**IN THE MATTER** of Notices of Requirement to enable the construction, operation and maintenance of the City Rail Link.

Statement of Evidence of N I Hegley

**Figure 1. Effects of Noise in the Studio**

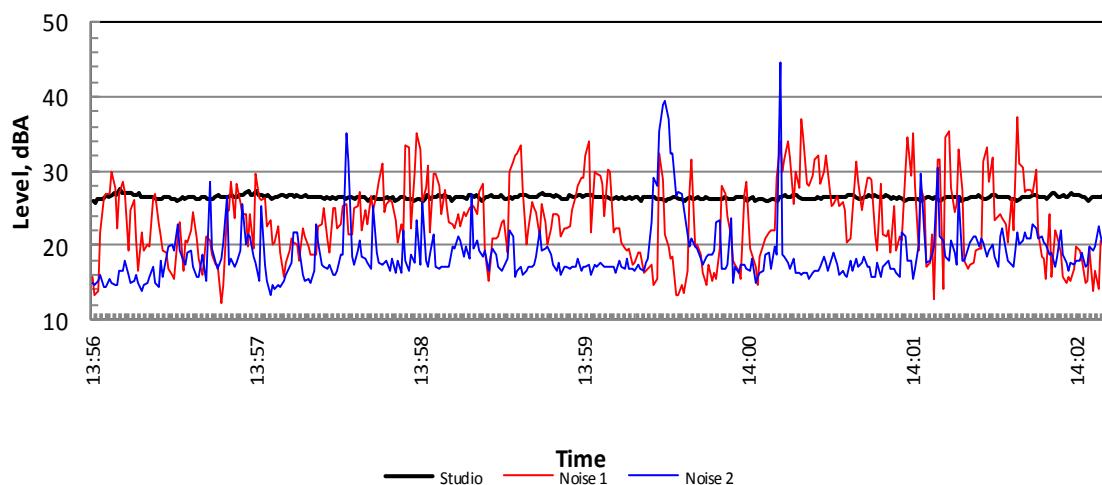
- 2.12 To demonstrate how any intruding noise can influence the recording studio I have plotted below in black the noise levels that I have recorded at the presenter's desk in the TV3 studio without the studio operating and then plotted in red and blue examples of other noise sources that have exactly the same average level (27dB  $L_{Aeq}$ ) over the identical measurement period of approximately six minutes. The results are shown on Figure 1.

- 3.1 Noise Source 1 is general mechanical plant activity and Noise Source 2 shows three trucks passing plus a number of smaller vehicles. These noise traces were taken from noise recordings I have undertaken at other sites and are not considered to be noticeably different to many other examples that would demonstrate a similar result. They are certainly not extreme examples of what may occur, such as blasting or pile driving.
- 3.2 A longer measurement period would enable even greater variation in the noise level providing the number of excess noise events is limited. For

- 3.3 From the example shown as Noise Source 1 on Figure 1 a level 6 – 7dB above the studio noise environment could be generated regularly and still comply with the same measured level as the existing noise level. For Noise Source 2 the existing studio noise could be exceeded by as much as 18dB over a six minute period and be within the current design level. As a guide, an increase of 10dB sounds twice as loud and an increase of 20dB four times as loud, so an increase of 18dB would have a significant impact on any recording being undertaken at the time.

- 3.7 When taking the above into account it is recommended the design level should be set at 25dB  $L_{Aeq}$  for any construction noise to allow the on-going use of the existing recording studio.
- 3.8 It is noted that the Construction Standard (NZS6803) acknowledges that higher noise levels are generally reasonable for construction works as the noise is of limited duration and communities will usually tolerate a higher noise level provided it is no louder than necessary, and occurs within appropriate hours of the day. However, this is not the case for some specialised activities and a recording studio that does not have a choice of when it is used is one such activity. It is because higher noise levels are not always reasonable that the word “usually” was included in the above statement rather than the word “always” or some such word.

**Figure 2. Effects of 40dB  $L_{Aeq}$  in the Studio**

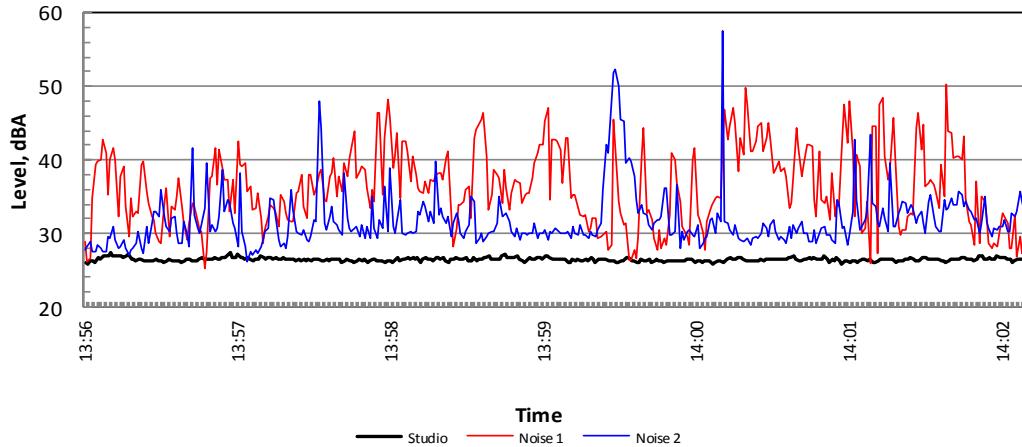
- 3.5 When taking into account the existing noise level of 27dB in the TV3 studio the proposal to allow a level of up to 40dB (which is approximately NR35) is would have a significant impact and well above the level recommended for a studio. This is demonstrated in Figure 2 where I have plotted the same noise traces as used in Figure 1 but increased Noise Sources 1 and 2 to have a level of 40dB over the monitoring period.

- 3.6 As can be seen from Figure 2, a level of 40dB is adopted as suggested then a transient machine working outside would result in levels as high as 58dB, or 31dB above the existing ambient sound within the studio, an increase from 27dB of approximately eight times. There is little doubt such an increase is excessive and would have a serious negative effect on any recording and could expect to be heard by the viewers.
